ENGINE - H.P. COMPRESSOR CASE - INTRODUCTION OF STRENGTHENED BORESCOPE BLANKING PLUG ASSEMBLIES AND GASKET SEALS AT STAGES 8, 9 AND 11 AND GASKET SEAL AT STAGE 7 - CATEGORY CODE 6 - MOD.ENG-72-0100

V2500-ENG-72-0100

## SERVICE BULLETIN

Location of borescope blanks  
Fig.1

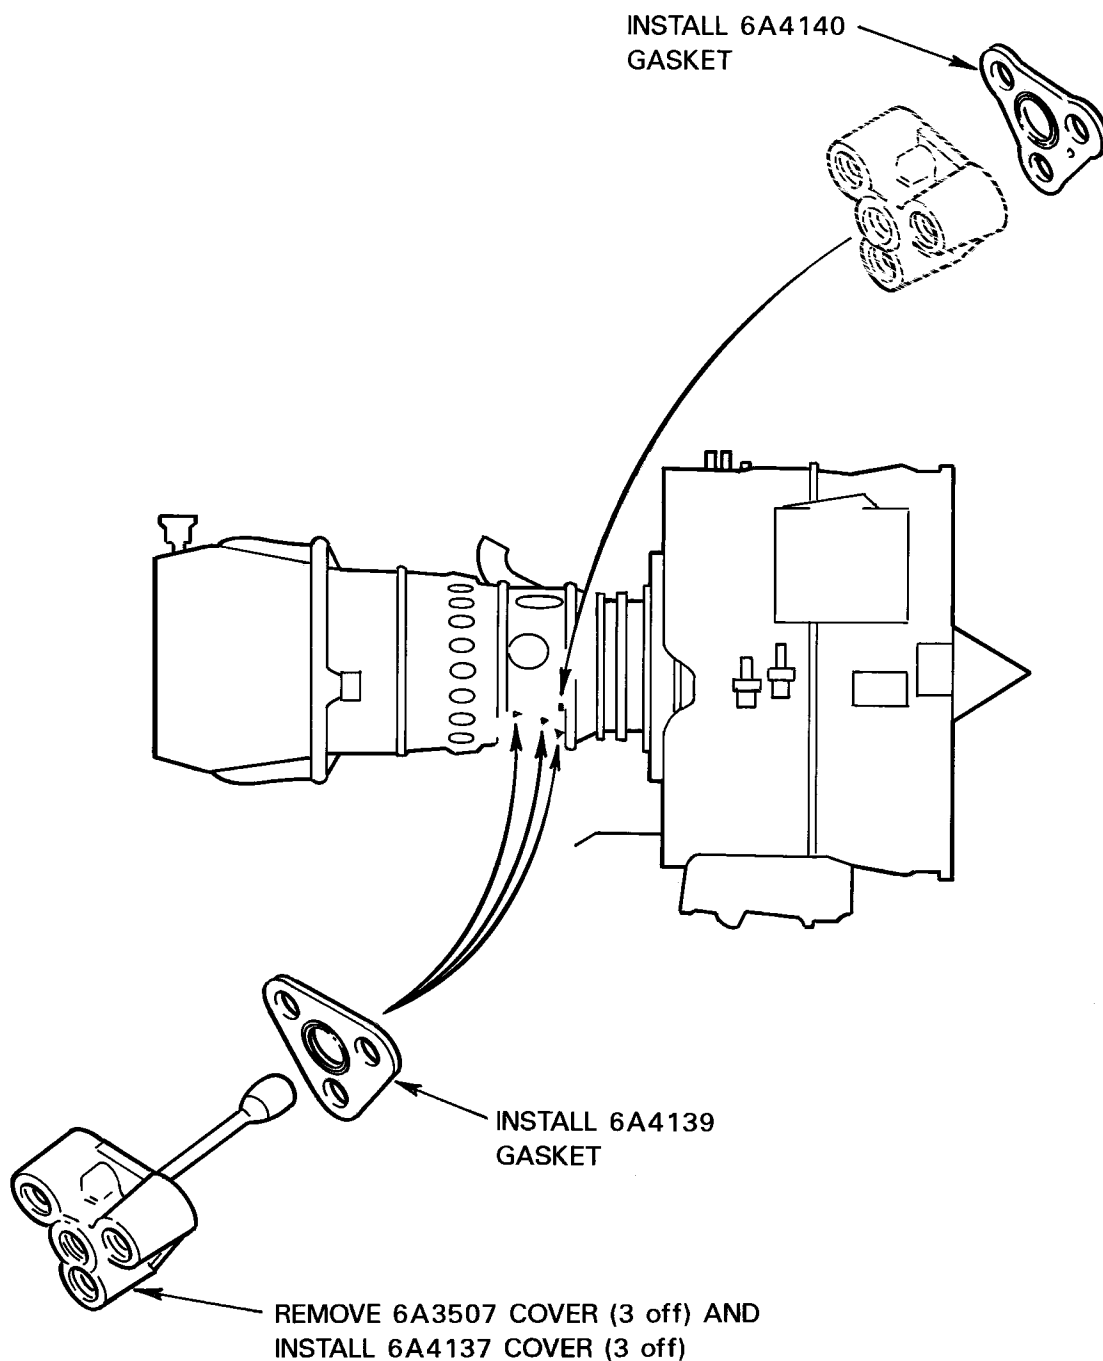
- (a) New borescope blanks are introduced at stages 8, 9 and 11 featuring a stem which has been strengthened by increasing its diameter from 1.5 (0.059in.) to 8,0 mm. (0.315in.). the stem welds have been eliminated by making the inner bulb integral with the stem and enlarging the stem at its outer end to form a spigot. The weld is not between the spigot and flange. The new flange incorporates 2 tapped holes. The assembly retaining bolts can be screwed into these holes to assist removal.
- (b) Corrujoints are introduced in place of jointing compound at stages 8, 9 and 11. This change is also applied at the stage 7 borescope location at which a flat blanking plate is fitted.

View of borescope blanks - Before and after alteration  
Fig.2

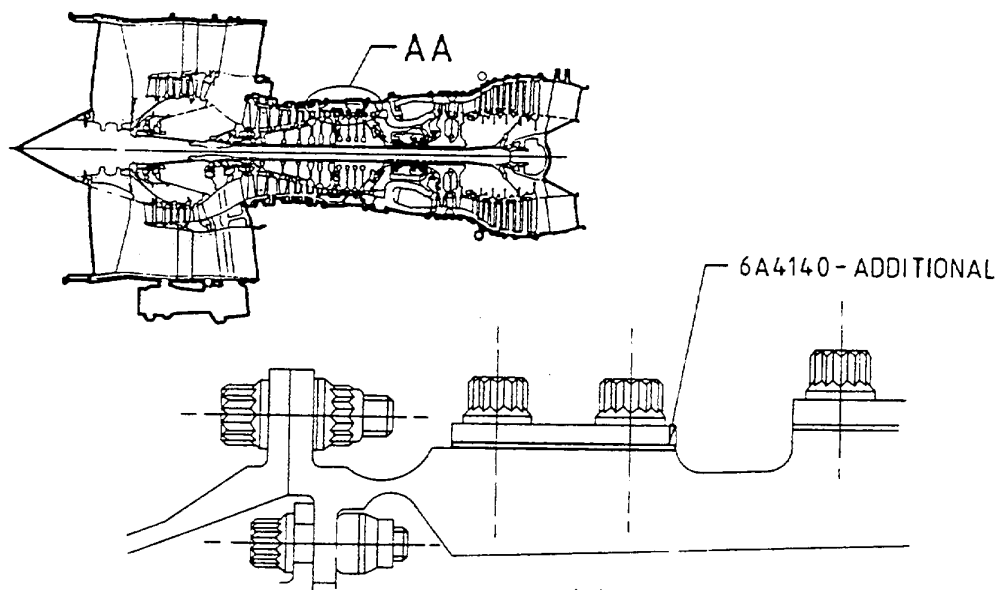
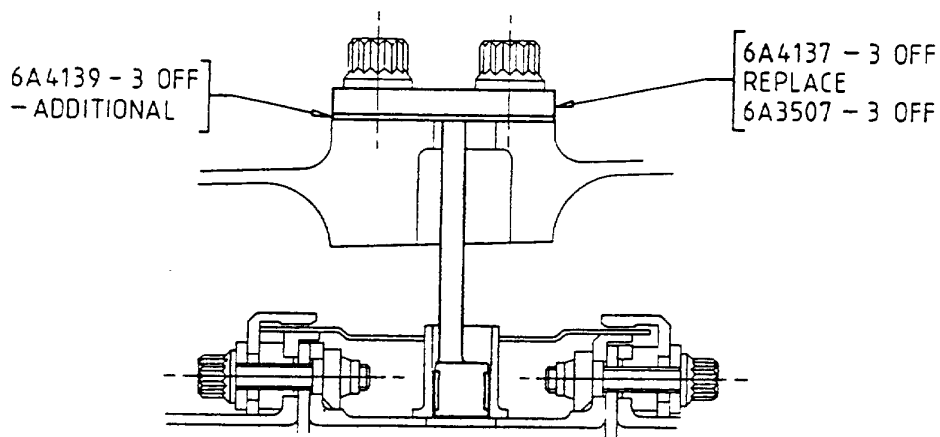
Breakage of the stem on the blanking plug assemblies during extraction has been reported. Breakage was at the weld beads at either end of the stem.

In addition, the use of SQ2 sealing compound between the plug flange and compressor case could result in a 'cement' seal. Consequently, excessive force may be required to break the seal before the assembly can be removed.

- (1) Assemble new 6A4137 borescope cover assemblies and new 6A4139 and 6A4140 corrugated gaskets by use of approved procedures, Engine Manual, 72-41-00 Assembly.
